Product Change Notice (PCN)

Subject: Packing reel change from 13-inch to 7-inch for Intersil *TKR5632 series products.

Publication Date: 11/6/2015

Top View

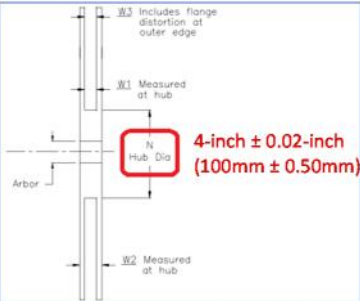
From	To
C	Packing reel outer dimension	13-inch \pm 0.02-inch (or 330mm \pm 0.50mm)	7-inch \pm 0.02-inch (or 180mm \pm 0.50mm)

Side View

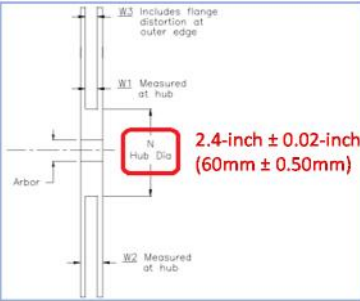
From	To
N	Packing reel hub diameter	4-inch \pm 0.02-inch (or 100mm \pm 0.50mm)	2.4-inch \pm 0.02-inch (or 60mm \pm 0.50mm)
